ADDENDUM NO. 1

TO THE INVITATION TO BID DOCUMENTS FOR Barnett Pump Station

May 6, 2025

CIVIL DETAILS - 2

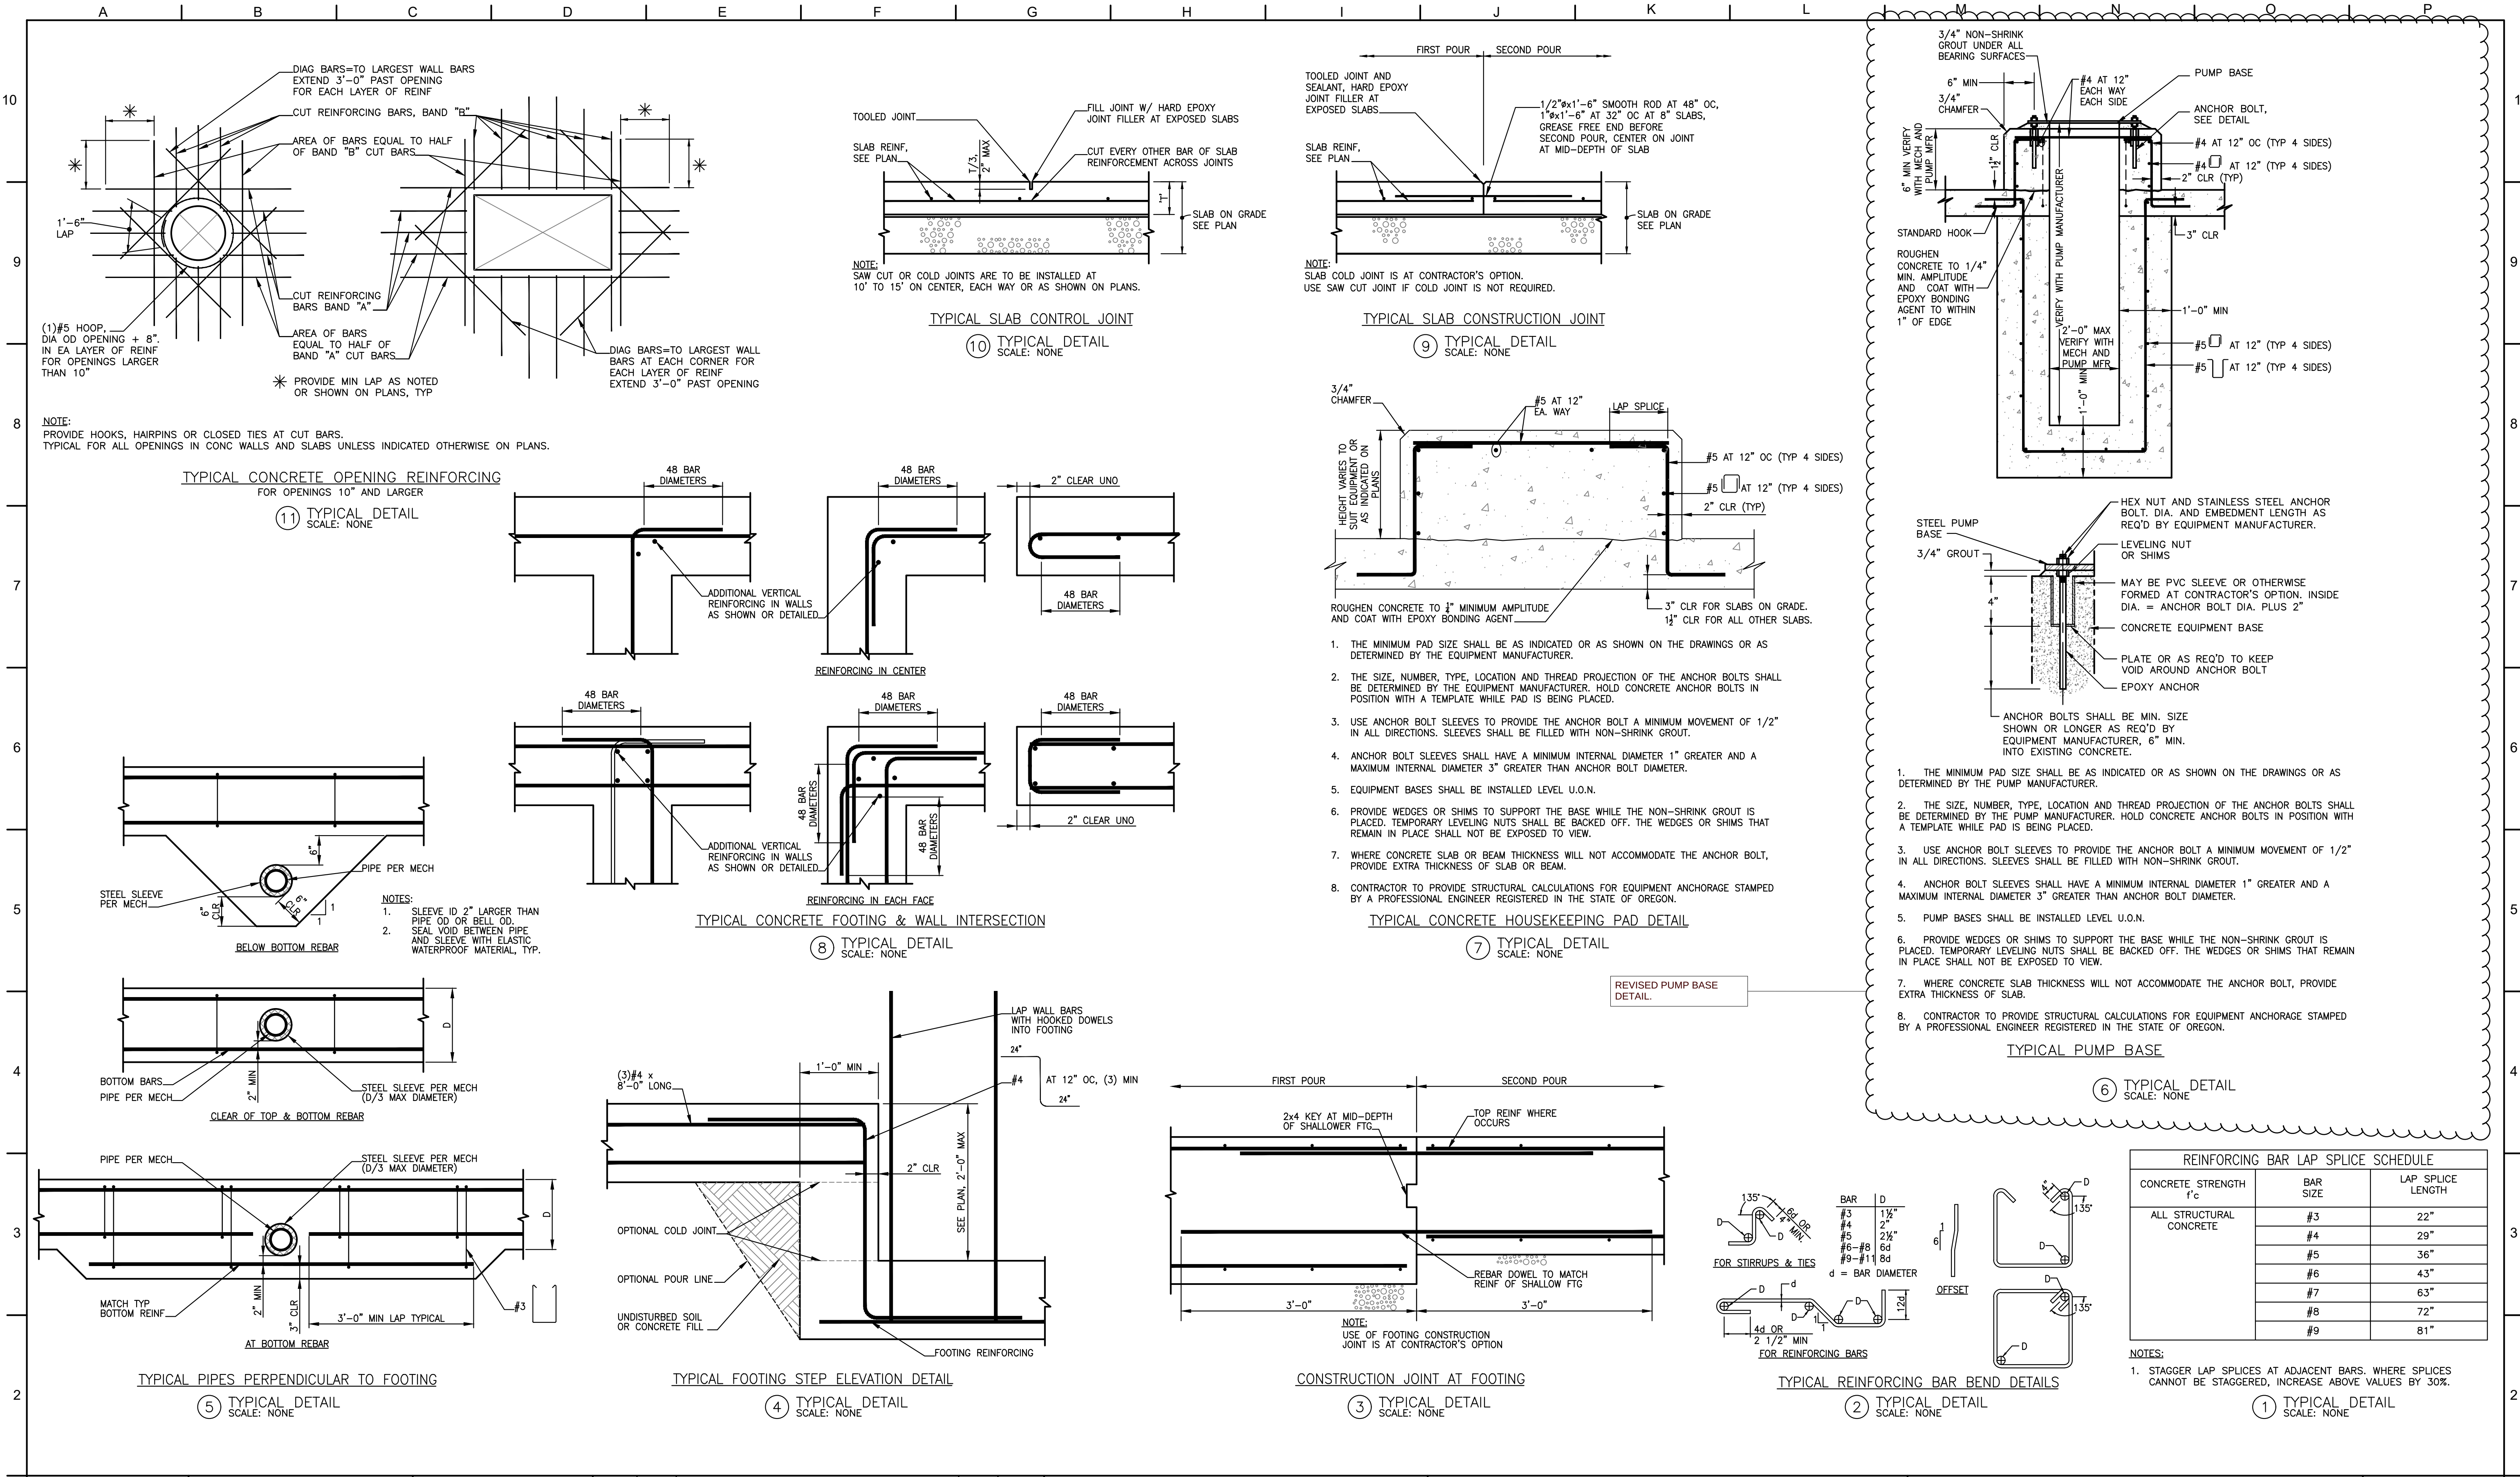
Item No.	Question	Response or Clarification
1-06	Detail 2 on Sheet C07, shows 12" tall by 6" wide concrete curb. Is the intention for this curb to be poured separate or monolithically with the sidewalk? Typically if poured monolithically, the thickened section of curb would taper at a 1:1 ratio from bottom of curb to bottom of sidewalk. Please clarify.	Install the curb first, separate from the sidewalk.
1-07	Detail 2 does not specify the thickness for exterior sidewalk.	Typical sidewalk thickness is 4". See revised 2/C07.
1-08	Will the transformer pad be provided by PacifiCorp?	The transformer vault is to be provided by the Contractor. Transformer vault must conform to PacifiCorp material requirements. Key Note 1 on E03 refers to specification section 26 00 05 for PacifiCorp Installation requirements. 26 00 05 3.10 Attachments: A. Pacific Power Details and Standards is included after page 14.
